Access Compliance Report

Public Rights-of-Way

| Intersection ID: 43512 | Main Street: BLUEBERRY_HOLLOW_PL | Cross Street: VICTORIA_BROOK_LN | Location: | N |
| ADA ID: 49FF4DA686AB | Ramp Type: Perp | Initial Pass/Fail: Fail | Overall Compliance: No | Severity Score: 22.5 |

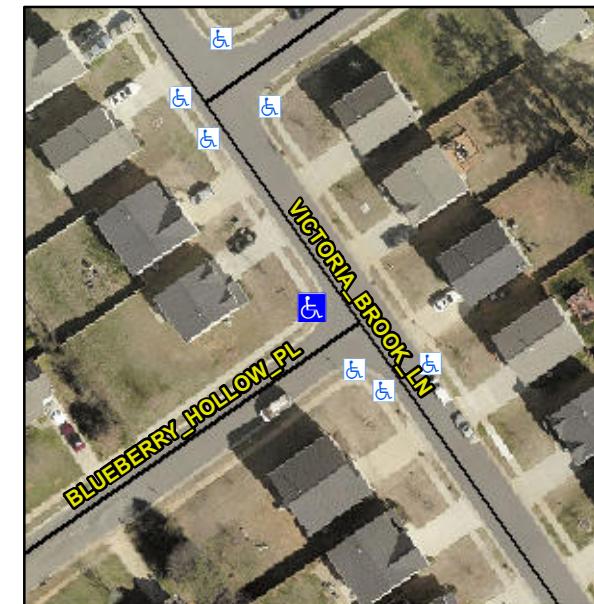
R304.5.1, R304.2.2, R304.5.3

| Compliance | Description | Data | Compliance | Description | Data |
|------------|-----------------------|------|------------|-----------------------------|------|
| N/A | Ramp Length (in) | 46.0 | No | Ramp Slope (%) | 8.9 |
| No | Ramp Width (in) | 46.0 | No | Ramp XSlope (%) | 2.5 |

Remove & Replace Entire Ramp.
